DEVIATION REQUEST AND DECISION FORM

Project Name :	Meridian Ranch Sports Center PPR	Date: 7/24/2024 Rev. 8/20/2024
Schedule No.(s) :	4220303009 and 4220303093	
Legal Description :	TR C ROLLING HILLS RANCH FIL NO 1 AT MERIDIAN RANCH TR B MERIDIAN RANCH FIL NO 8

Exclusive Right Turn Lanes Required (7/23/2024; Rev. 8/20/2024): A deviation from the standards of or in Section 2.3.7.D.2 of the Engineering Criteria Manual (ECM) is requested. The request is NOT to add right-turn lanes for southbound and westbound approaches at the intersection of Londonderry/Rainbow Bridge intersection. Although the turn-volume threshold is met, the intersection is an all-way, stop-sign-controlled intersection and that is not likely to change.

Deviation Exhibit No. 1

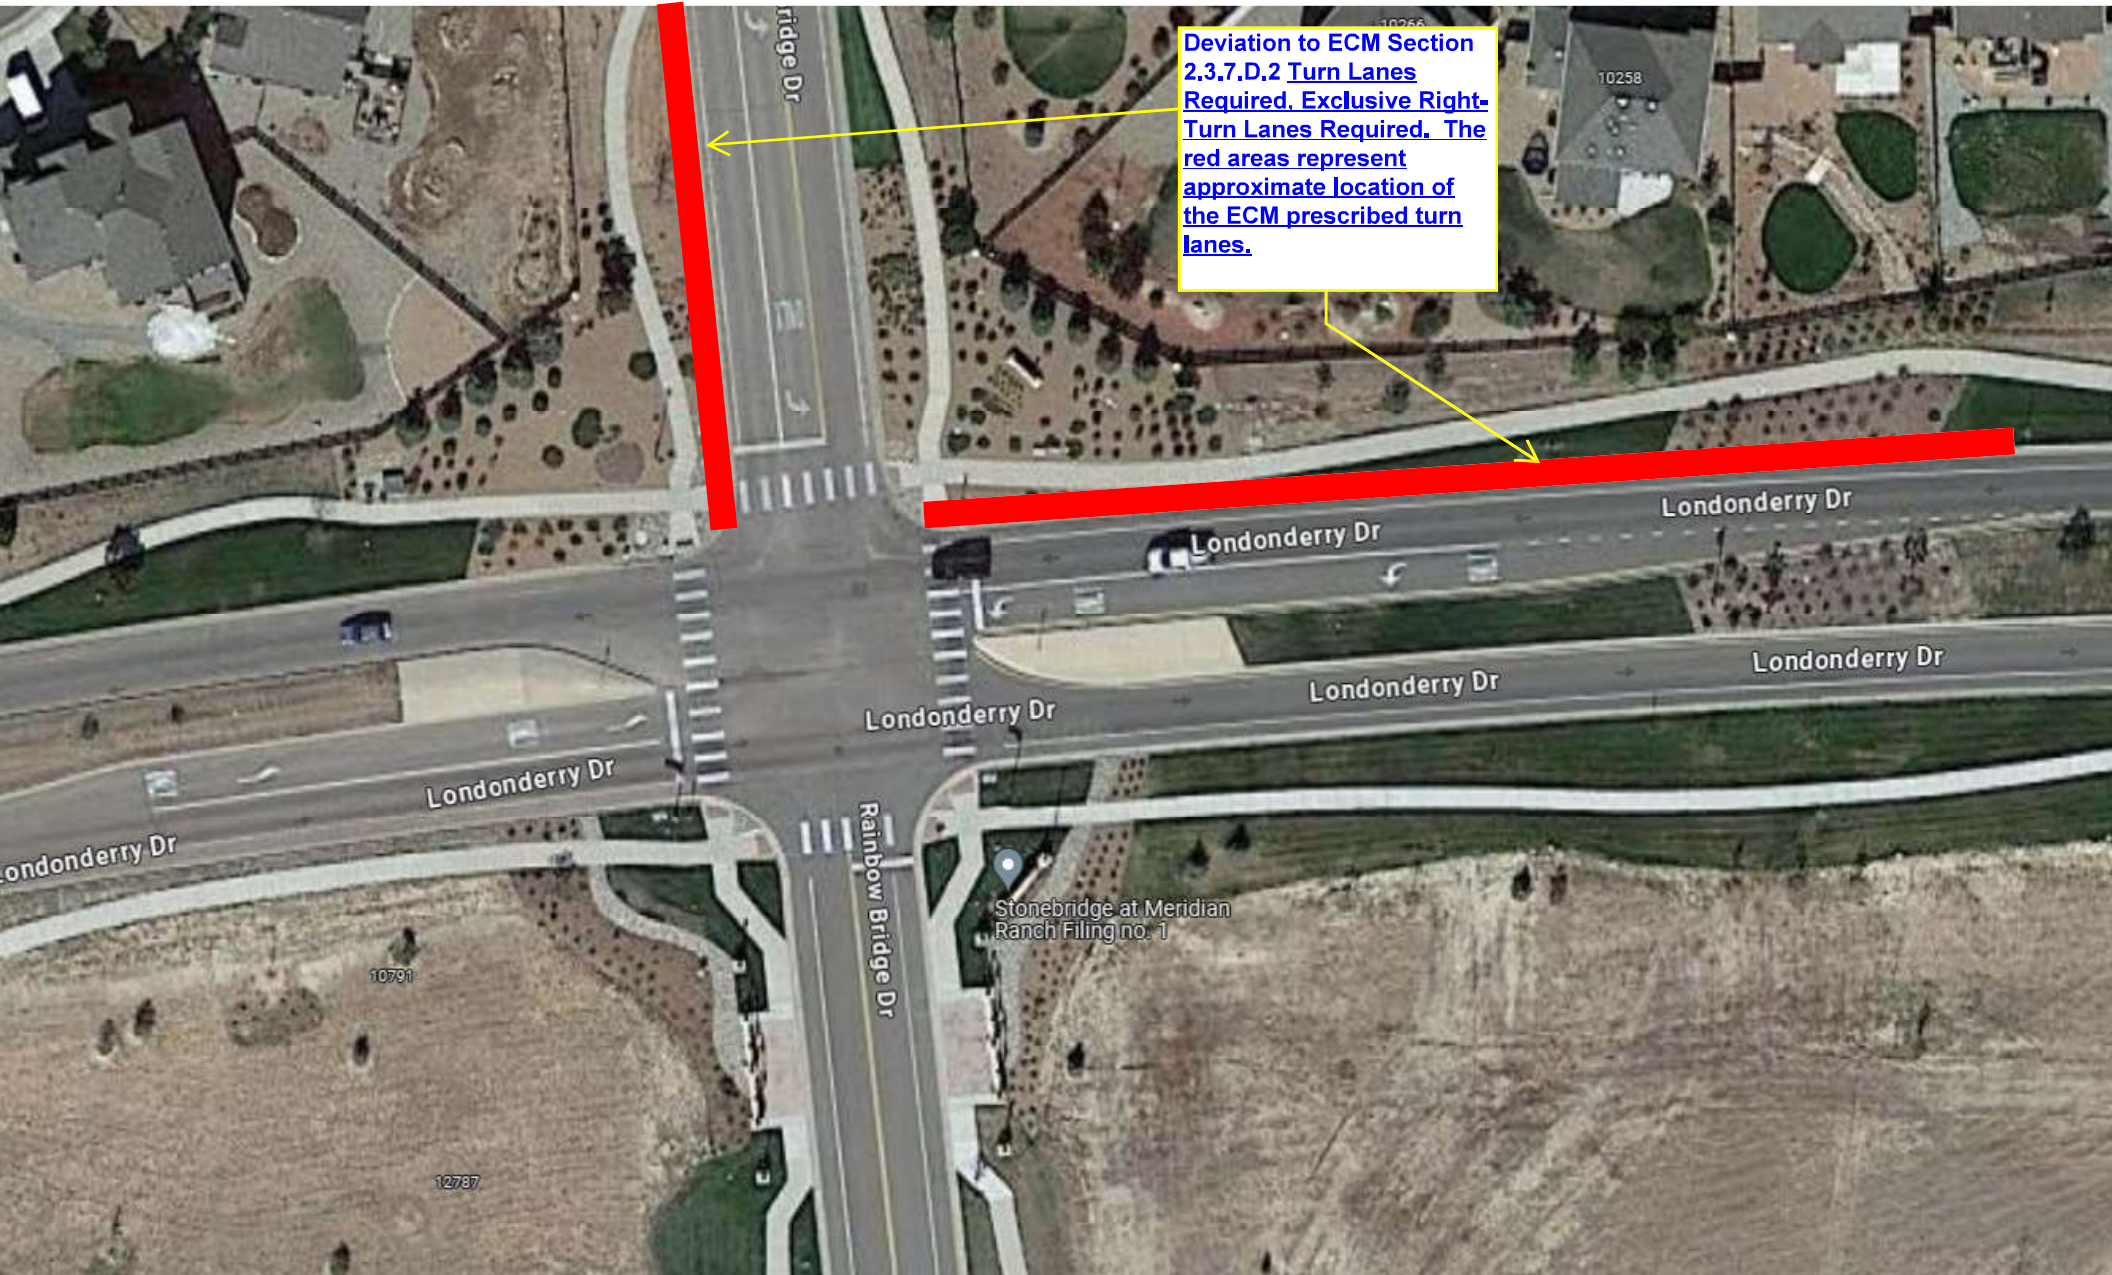
Deviation Exhibit No. 1 shows the subject intersection location, Deviation Exhibit No. 2 graphically summarizes the request, and Deviation Exhibit No. 3 provides an excerpt from the TIS.

Deviation Exhibit No. 2
Requested Deviation

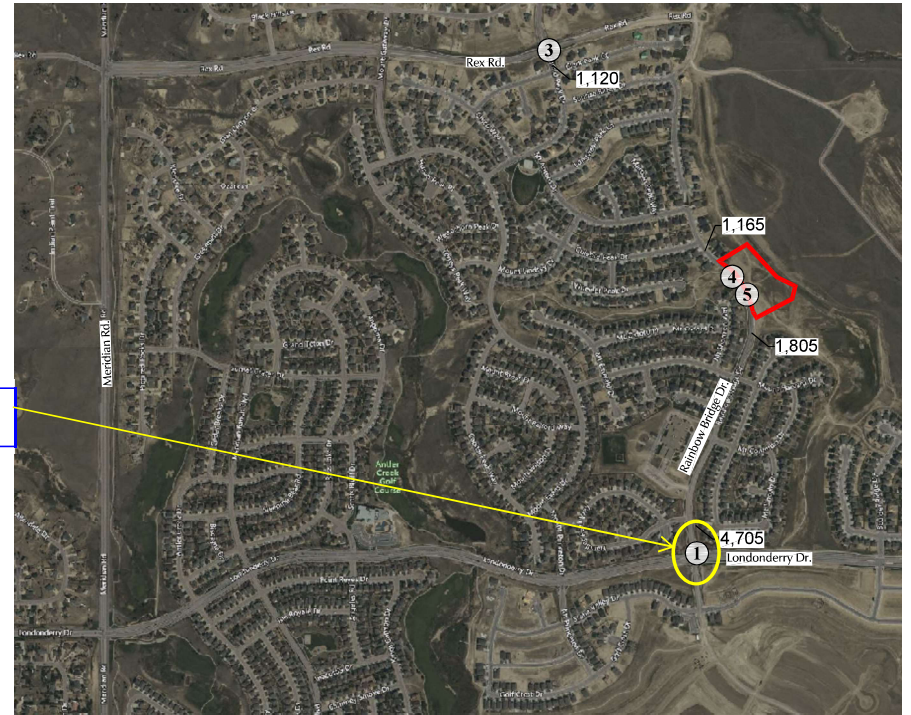
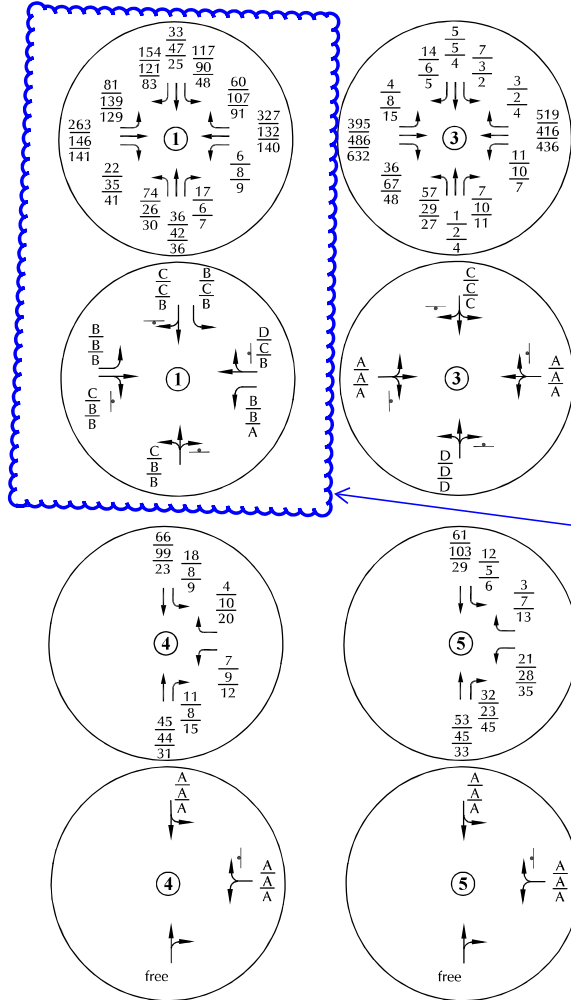
Deviation to ECM Section 2.3.7.D.2 Turn Lanes Required, Exclusive Right-Turn Lanes Required. The red areas represent approximate location of the ECM prescribed turn lanes.
